Wiring changes from HK32EA001/007 board to HK32EA003/008 (Quiet Shift) board

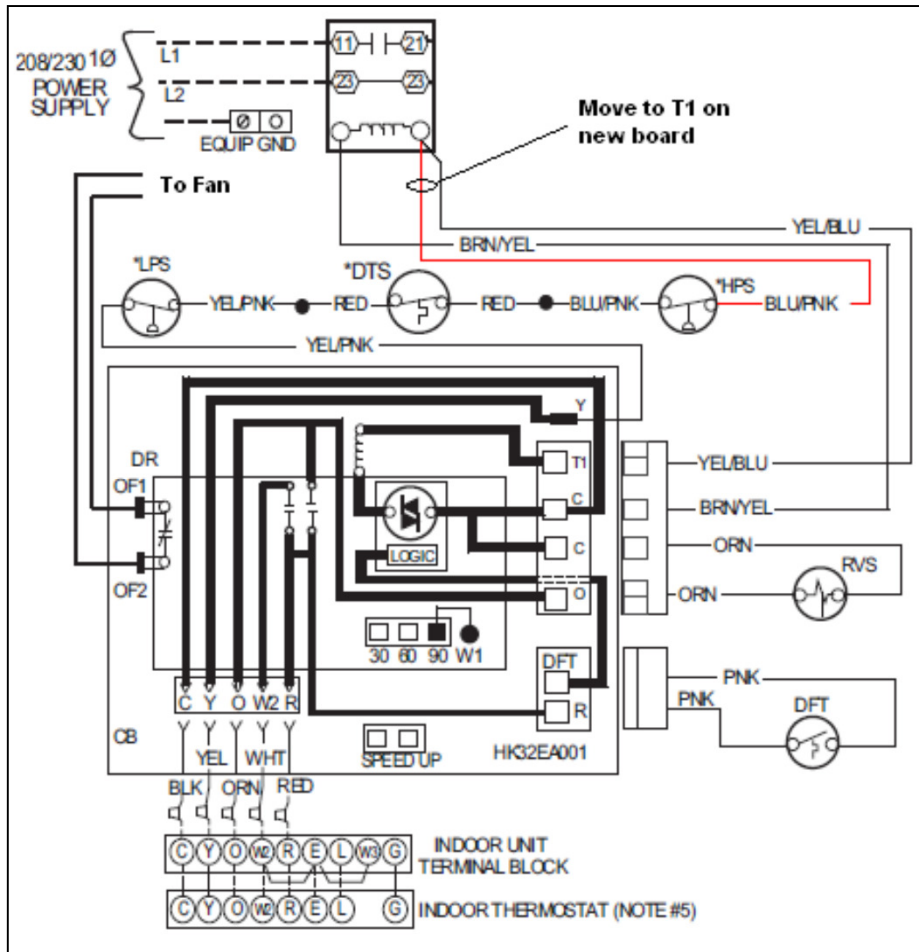
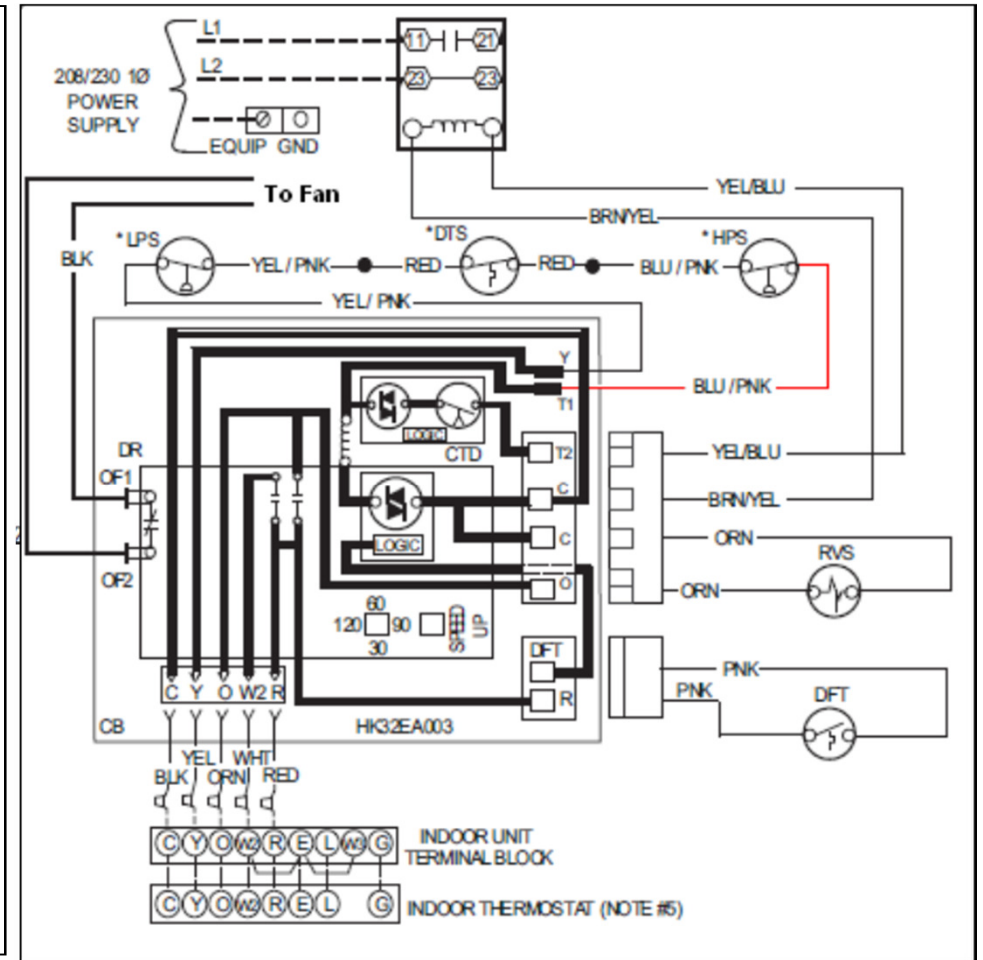
Original Board - Take BLU/PNK wire off of compressor contactor coil stake-on and move to T1 on the new board.

New Board – Note BLU/PNK wire has been moved from compressor contactor coil to T1 on the new board.
